RE: Response To Ten-Day Notice X-95-020-109-01 TV1, Genwal Coal  
Company, ACT/015/032, Folder #5, Carbon County, Utah

Title of Change: Response TDM - Change SAE-2 to ASCA-3 with treatment

95-D

**Title of Change: Response to OSM TDN on SAE-2**

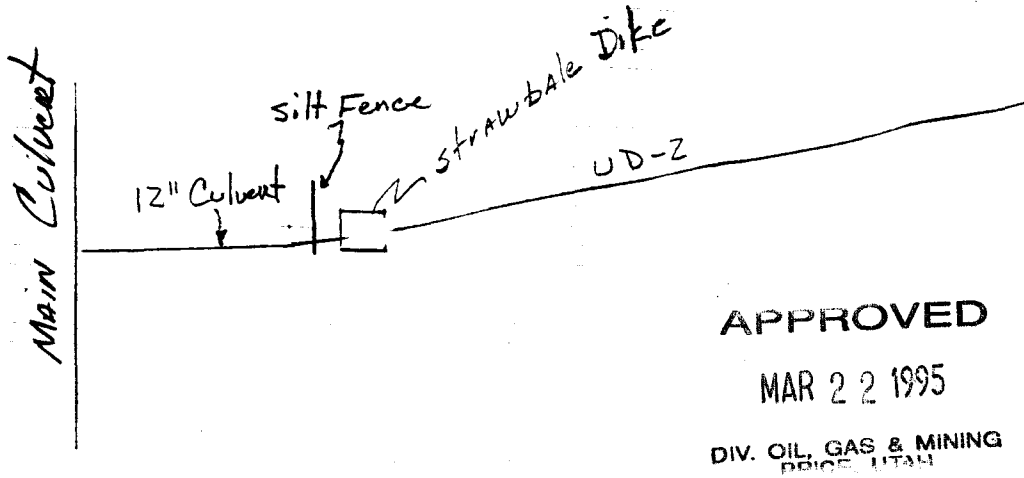
ASCA-2 was reclaimed (contemporaneous and final) as outlined in Section 525.300. A 12-inch CMP culvert was installed at the end of UD-2 to collect the diverted runoff. This 12-inch culvert (UD-2) discharges into UD-1. A strawbale dike and silt fence will be constructed at the inlet (see Figures 7-11 and 7-12) to the structure ensure all the runoff water from the disturbed area is treated. Also, to ensure that the runoff does not overtop the siltfence, the silt fence will extend a minimum of 18 inches above the ground surface and will be cleanedout when only 12 inches remain above the ground surface to insure that the effluent meets state and federal regulations. ASCA-2 will be inspected monthly for sediment buildup and structural integrity.

3-22-95  
ASCA-2  
Silt Fence

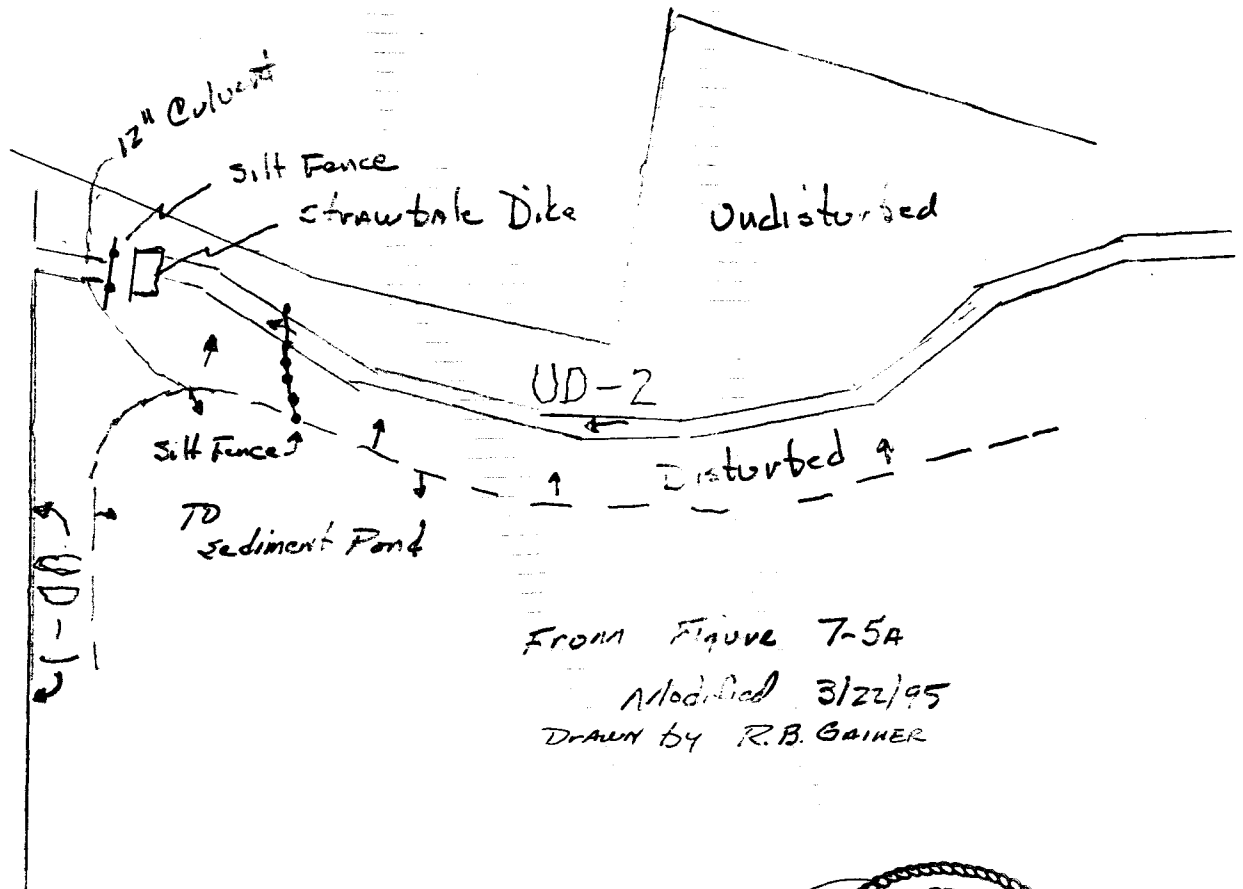
SAE-2 now referred to as ASCA-2 (0.34 acre) exists at the northwest corner of the site. This area was initially constructed as a substation pad and associated access road. Because the substation has not been installed and may not be installed in the future, ASCA-2 is being reclaimed. Of the total area, 0.15 acre received final reclamation treatment and 0.19 acre received contemporaneous reclamation treatment (see Chapter 5, Plate 7-16 and Plate 7-5C). An additional area of 0.90 acre of undisturbed area drains onto ASCA-2 from above. The 24-hour design storm flow from the area (disturbed and non-disturbed areas) is 2.4 cfs
